Statement of Facts and Contentions

Court	Land and Environment Court of NSW
Division	Class 1
Registry	Land and Environment Court Sydney
Case number	2025/00388660

First Applicant	PLACE STUDIO AU PTY LTD ABN 87611292187
First Respondent	Ku-ring-gai Council ABN 86408856411

1. This is an appeal against the deemed refusal of the Development Application which seeks development consent for the demolition of existing dwellings, consolidation of lots and construction of a 7-storey residential flat building with basement parking at 7-11 Pockley Avenue, Roseville (the **Site**).
2. The Development Application, seeks consent for the following (**Proposed Development**):
 - a) consolidation of 3 lots;
 - b) demolition of the 3 existing 1-2 storey residential dwellings and ancillary structures as shown on the demolition plan;
 - c) 3 levels of basement comprising:
 - i. 73 x resident parking spaces (including 9 x accessible spaces)
 - ii. 11 x visitor parking spaces (including 1 accessible space)
 - iii. 51 x bicycle parking spaces in bicycle storage room or racks (including 7 for visitors)
 - iv. Loading bay
 - v. Waste chute and waste storage rooms

Figure 10 – Building height plane as shown within architectural plan sheet number DADA.05.80 Revision B

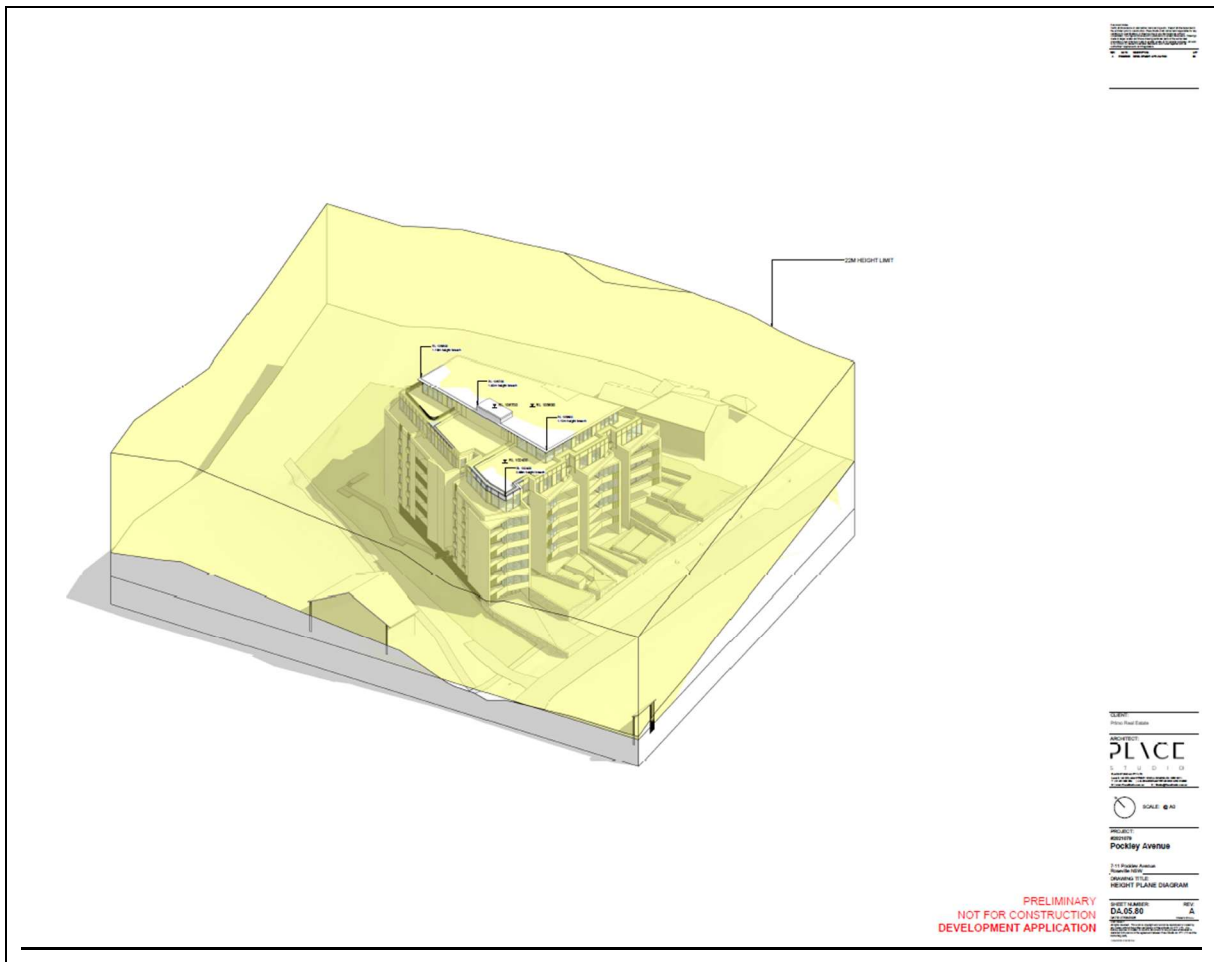
- a) The architectural Height Plane Diagram sheet number “DA.05.80 Revision A”, shows various breaches of the 22m maximum building height. The Clause 4.6 Request defers to this plan for the calculation of building height.

- b) The Height Plane Diagram does not provide an accurate calculation of building height as it utilises ceiling levels, i.e. RL102.4 for the breach in relation to Unit 5.01. The breach is caused by parapet and roof levels, which are above the ceiling level. The specific height of these elements is not specified on all the sections and elevations. The natural ground level that is annotated on the survey plan is not shown on the sections. This information is required.

- c) The KLEP definition of “building height” requires that height be measured from the ‘natural ground level (existing)’. An overlay of the roof plan and the survey plan is required to demonstrate that the building height has been measured in accordance with the requirements of the KLEP.

- d) The Clause 4.6 Request does not explain why it is necessary for the lift overrun to breach the height limit. The Request should explain why an alternative lift design that would require a lower overrun or no overrun is not feasible for the proposed development.

- e) The Clause 4.6 Request should include more detailed commentary about the overshadowing impact of those building elements that breach the building height, including when the impact occurs and commentary on any impacts upon existing and likely future development of properties in the vicinity of the Site.

Figure 7C.3-2:
Ground floor apartments located below ground level

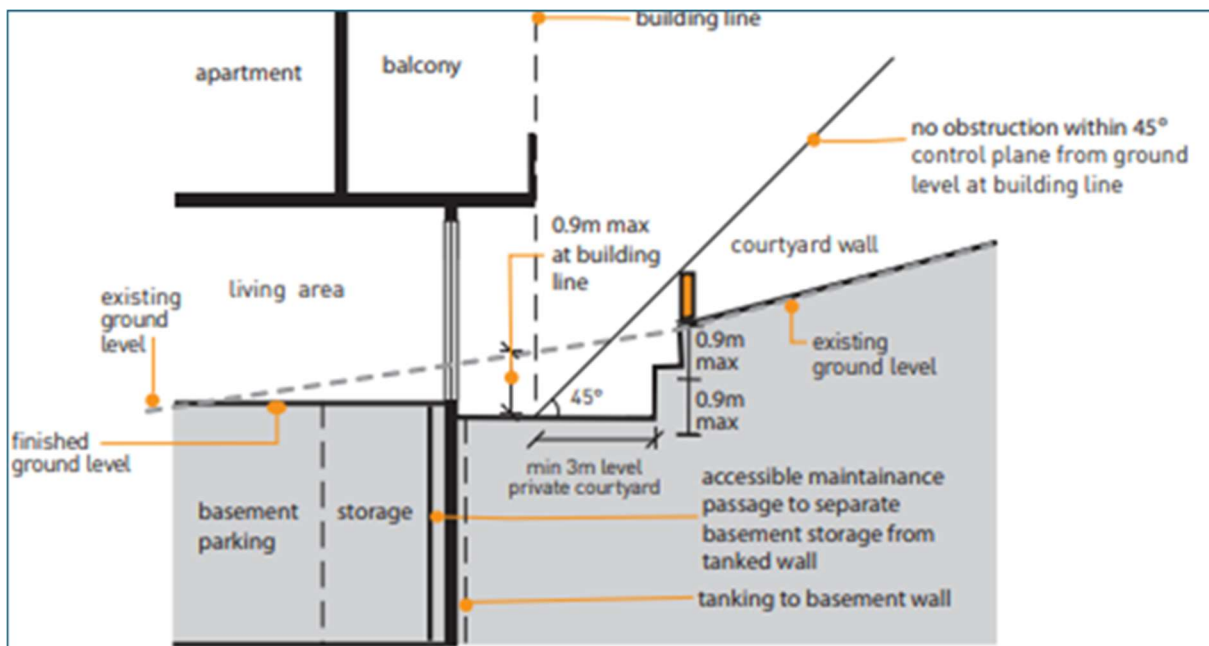
- e) The large basement communal storage area at Upper Ground Level, shown on plans DA.01.11A, appears to be subterranean and not be separated from a tanked wall by an accessible maintenance passage. An accessible maintenance passage, as shown by Figure 7C.3-2 of the KDCP (shown below) is required:
